UNITED STATES PATENT AND TRADEMARK OFFICE

APPLICATION NO.	FILING DATE	FIRST NAMED INVENTOR	ATTORNEY DOCKET NO.	CONFIRMATION NO.
10/799,307	03/12/2004	Jae-Hyun Kim	8054-50 (LW9007US/HJ)	8101
22150	7590	06/29/2005	EXAMINER	
F. CHAU & ASSOCIATES, LLC 130 WOODBURY ROAD WOODBURY, NY 11797			CHIEN, LUCY P	
			ART UNIT	PAPER NUMBER

Office Action Summary

DETAILED ACTION

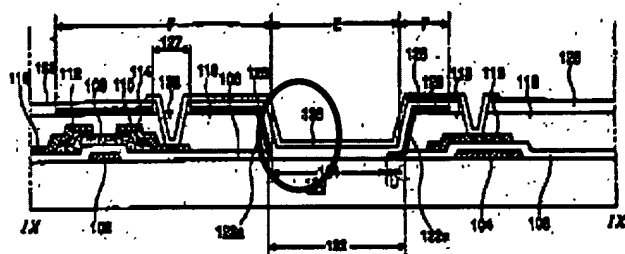
Park et al does not disclose the second edge of the reflecting area adjacent to the transmitting area removed by a predetermined width toward the extended direction of the first edge.

Ha et al discloses in Figure 9D the second edge (circled below) edge removed from the transmitting area thus the distortion from a fringe field can be prevented. And the transmissive area is widened as shown. (Column 12, Row 49-60)

It would have been obvious to one of ordinary skill in the art, at the time of the invention to combine the teaching of Park et al's display device to include Ha's teachings of having one side of the transmissive part overlapped in order to prevent distortion from a fringe field. (Ha et al, Column 12, Row 49-60)

Fig.4

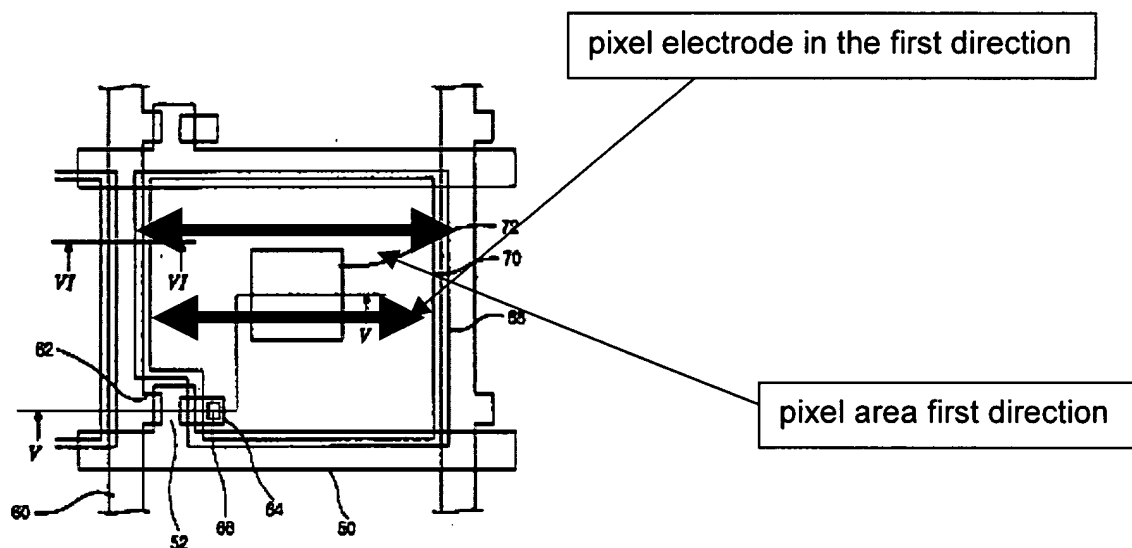
Park et al further discloses in Figure 4 (and figure below) the width of the pixel electrode in the first direction is smaller than the width of the pixel area in the first direction.

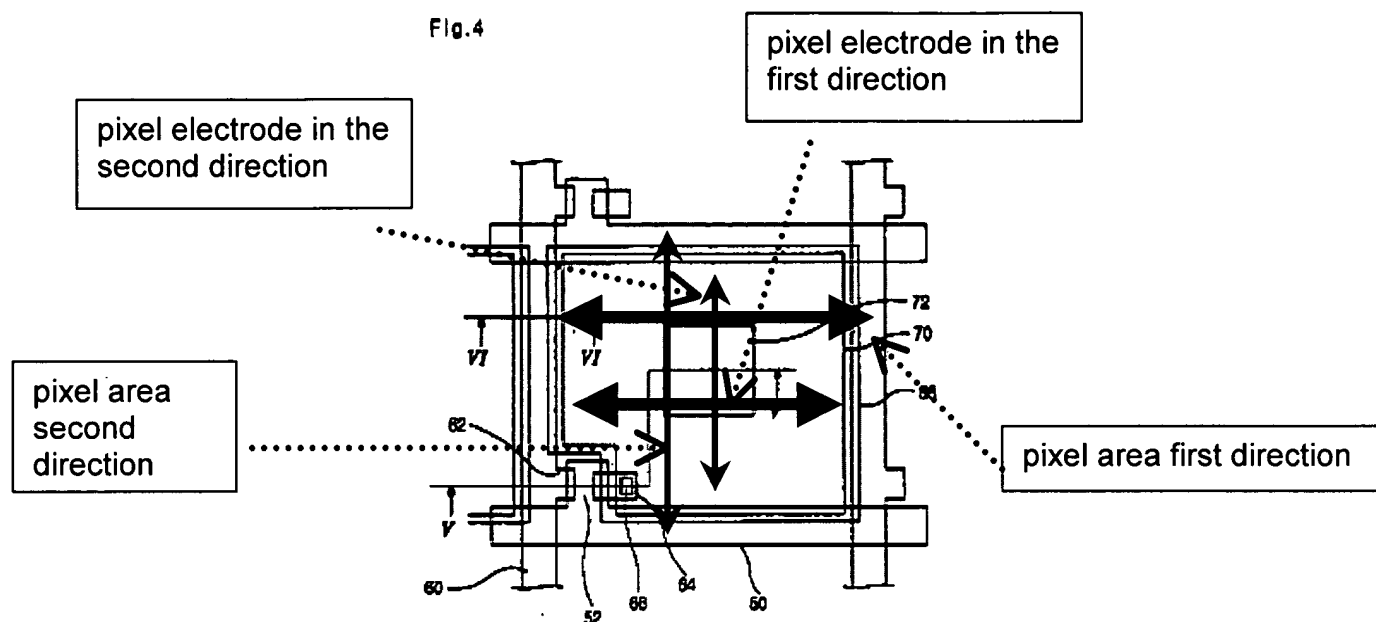
Park et al further discloses in Figure 4 (and figure below) the width of the pixel electrode in the first direction and width of the pixel electrode in the second direction are

smaller than a width of the pixel area in the first direction and a width of the pixel area in the second direction.
